CITY OF NORTH RICHLAND HILLS

20-004 PUBLIC WORKS RESTROOM RENOVATION PROJECT
ADDENDUM NO. 2

NORTH RICHLAND HILLS SERVICE CENTER REMODEL
7200 A DICK FISHER DRIVE SOUTH
NORTH RICHLAND HILLS, TEXAS 76180

F9 PARTIAL REFLECTED CEILING PLAN - TOILET RENOVATIONS
SCALE: 1/4" = 1'-0"

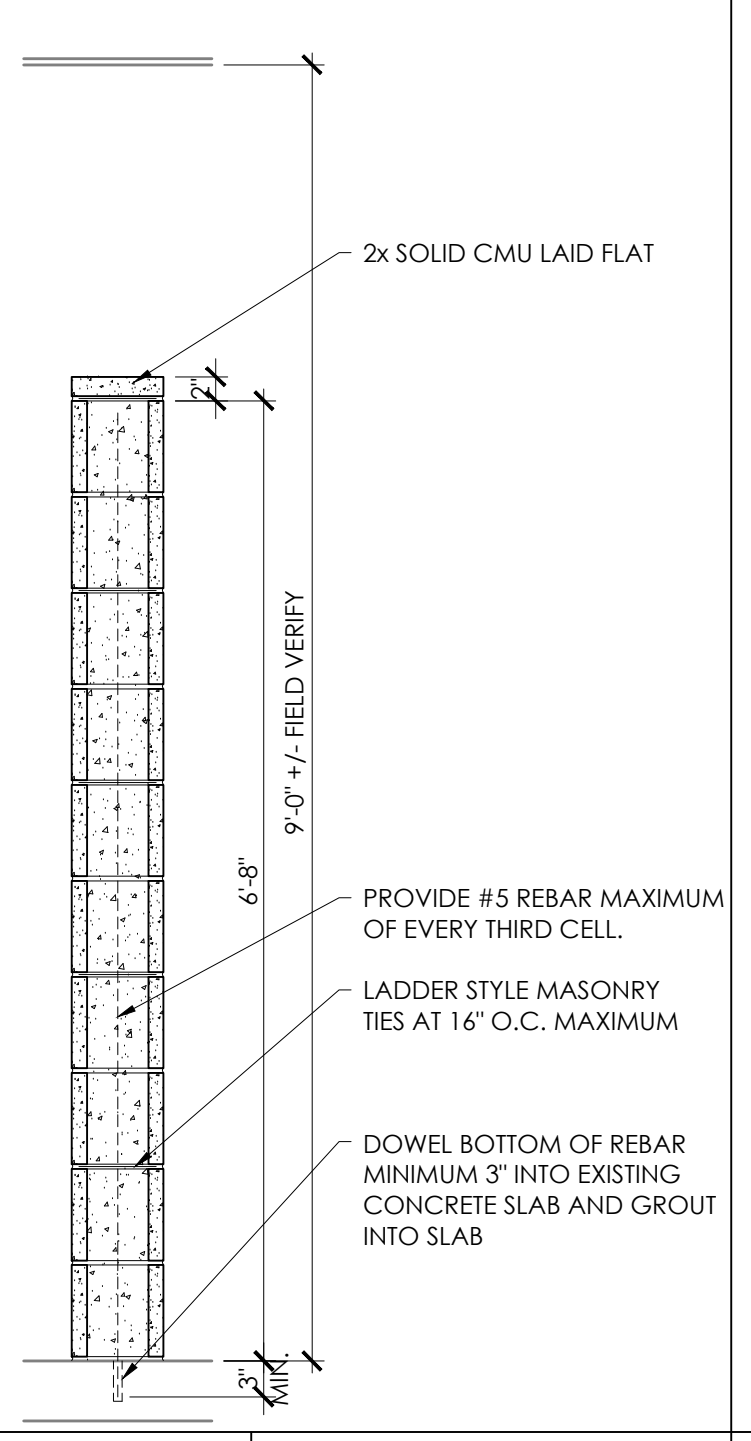
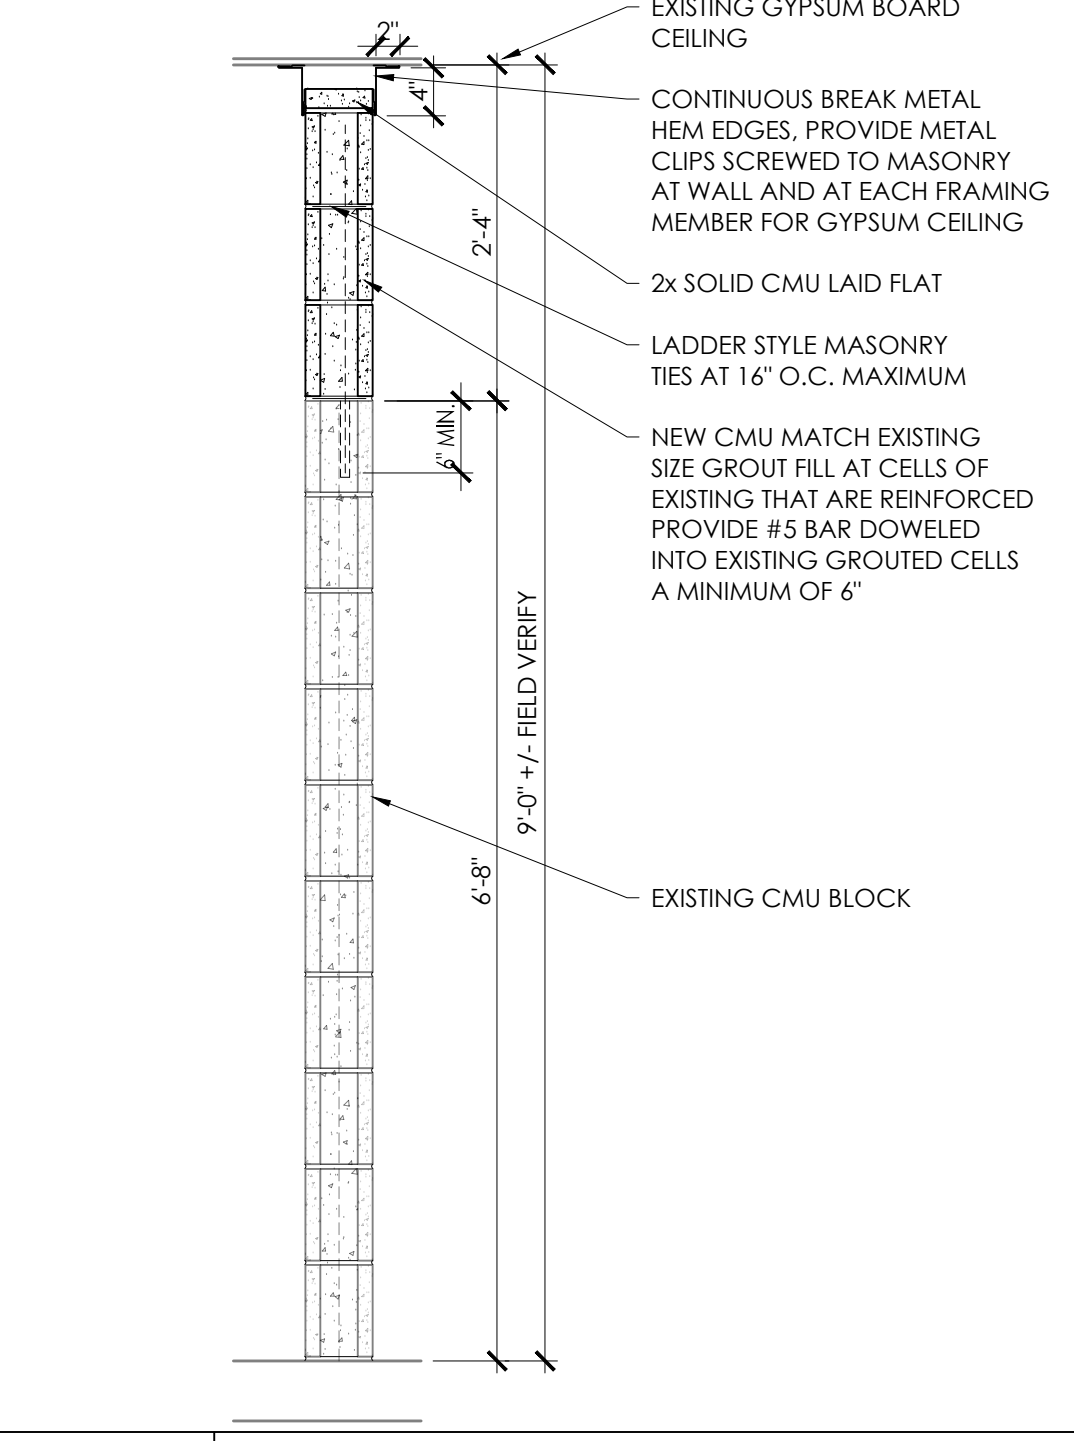
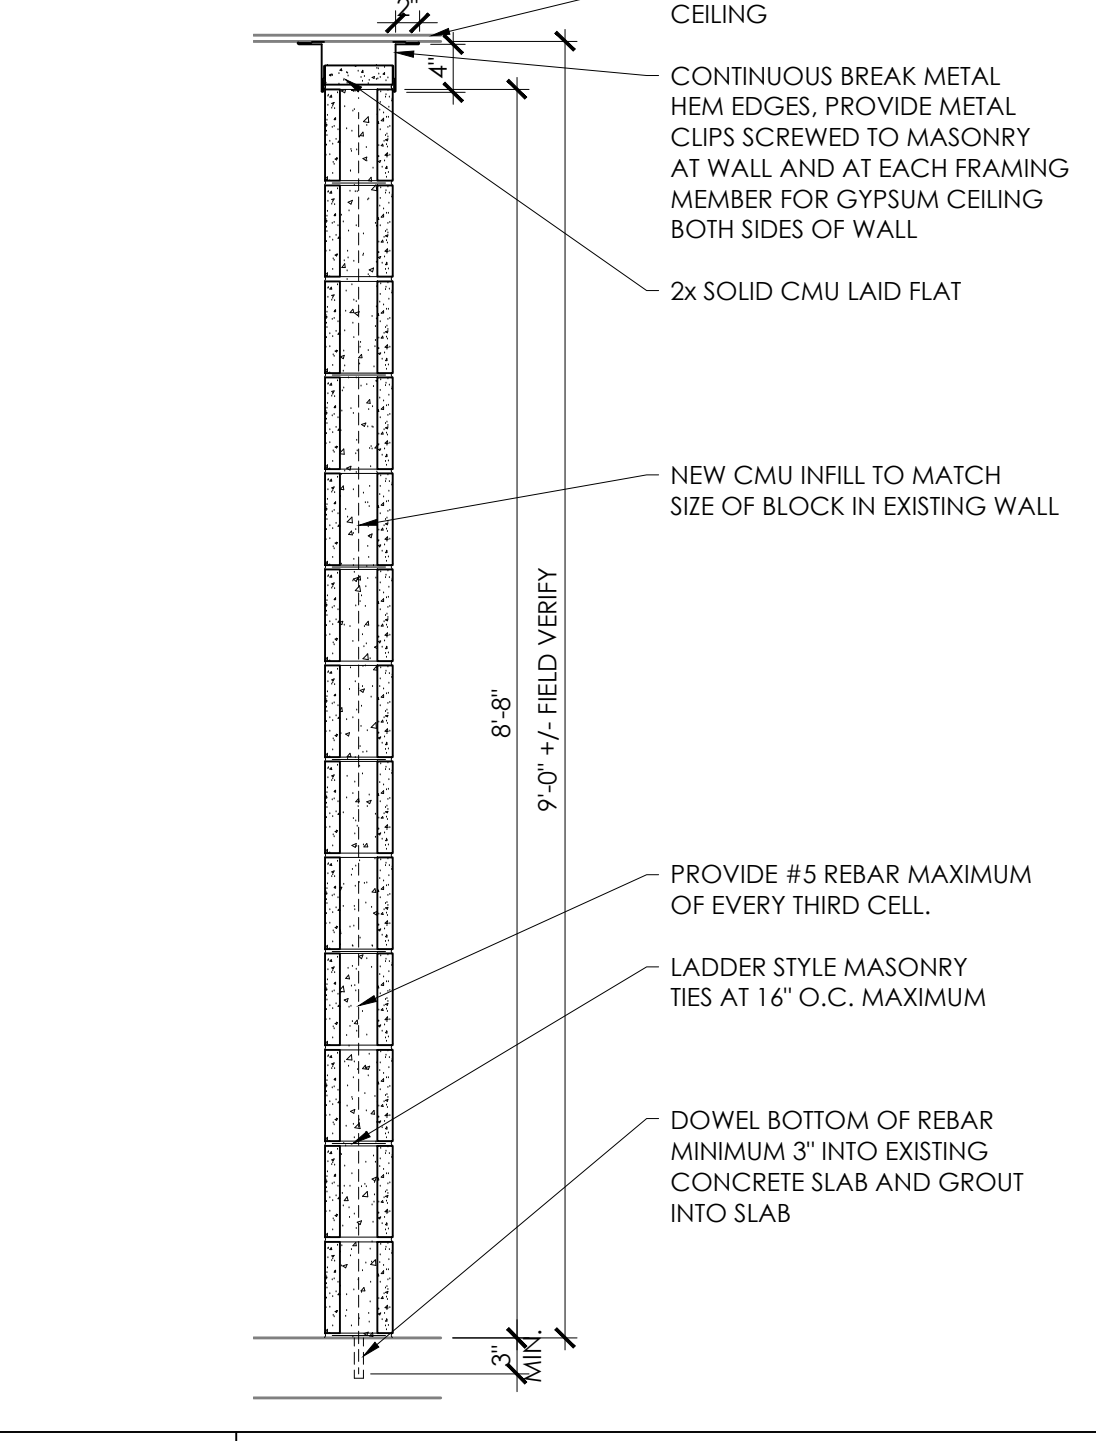
- 1) Specifications provided for the New Toilet Partitions, hardware and Toilet Stalls Accessories
- 2) On the Demolition plans, Sheet A101 has been replaced with attached drawing A101 REV1.
- 3) ADDENDUM NO. 1 is the pre-bid meeting minutes and sign-in sheet, and will not have a separate signature sheet.
